Town of Parker Community Development Department
Development Review Division
Attention: **Stacey Nerger**

Application Type: **Site Plan**
Status: **First Referral**
Application Name: **Lincoln Professional Park F1 - Preliminary Site Plan**
Case/AP#: **SP21-107**
Referral Received: September 22, 2021
Comments Due: October 20, 2021

Review date: **October 14, 2021**
Plan reviewer: **Randall L. Capra, rcapra@parkeronline.org**
Phone: 303.805.3163

TOWN OF PARKER FIRE/LIFE SAFETY:	R REVIEWED FOR CODE COMPLIANCE; REVISIONS REQUIRED
---	---

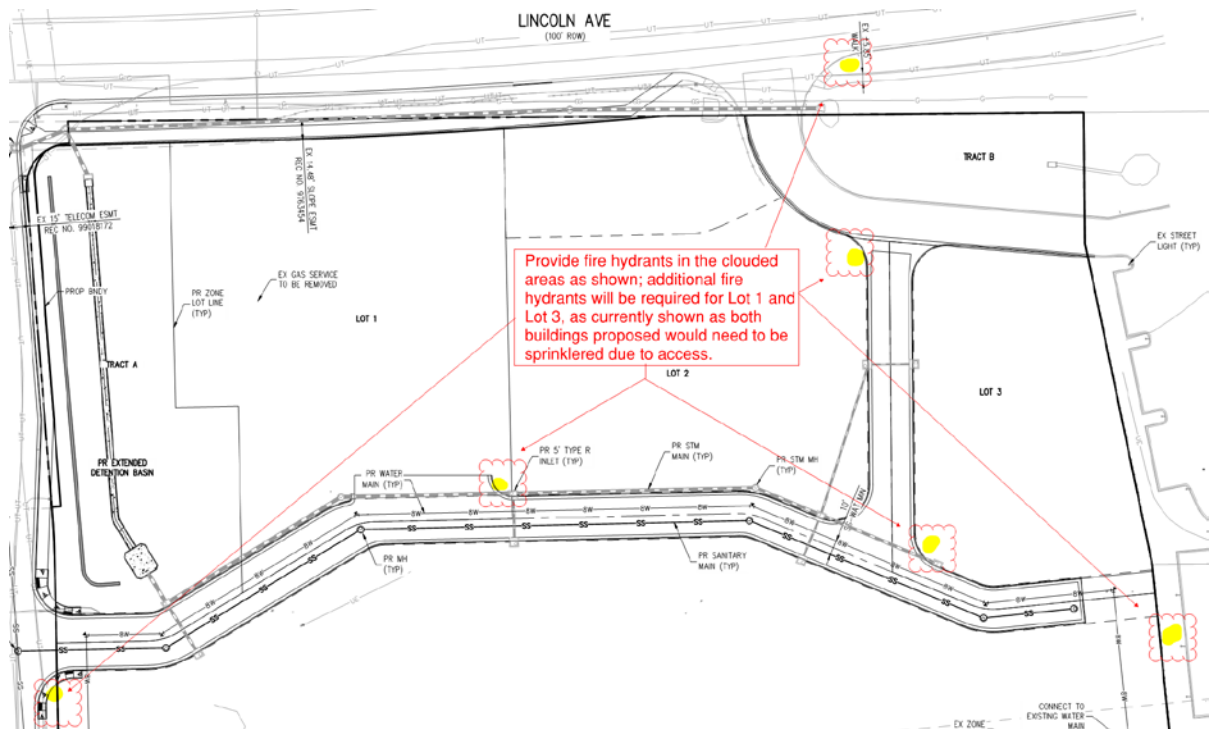
8. **Sheet 3 Overall Utility:** The overall utility drawings are incomplete; the plan set does not address fire hydrant locations for the spine roads proposed. The applicant shall address this issue and fire hydrants will be required in the following locations while noting that additional hydrants will be required on the internal lots depending upon access and use (the gas station will be required to be sprinklered as will Lot 3... as currently shown):

- The entry off of Dransfeldt Road on to Road A
- The entry off of Lincoln Ave and the current Private Drive
- Road A (required extension) into Lot 1 Filing No.2 Peaslee Subdivision at Road A and Lot 1
- At the corner of Road B and the Private Drive
- At the corner of Road A and Road B
- At the entry of the gas station off of Road A

See below for locations required:

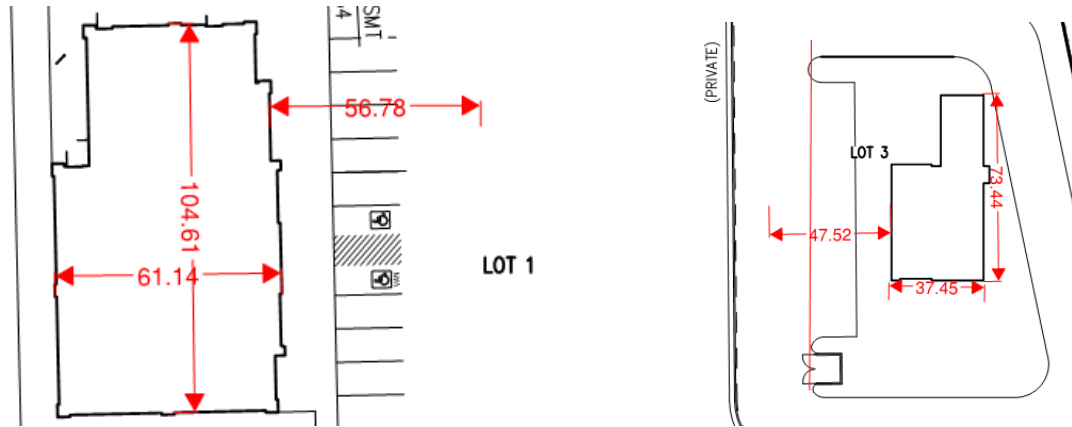
As noted above, the buildings on Lot 1 and Lot 3 (in the configuration shown) will be required to be sprinklered due to the inability to provide access to all portions of the building (as measured by an approved route by the "fire

code official". Per [18 IFC 503.1.1 Buildings and Facilities], the code does allow the distance to be increased when the building is fully sprinklered. This issue shall be addressed when resubmitting. *NOTE - The location of the riser rooms must be approved; the required fire hydrants for each of the condominium buildings*
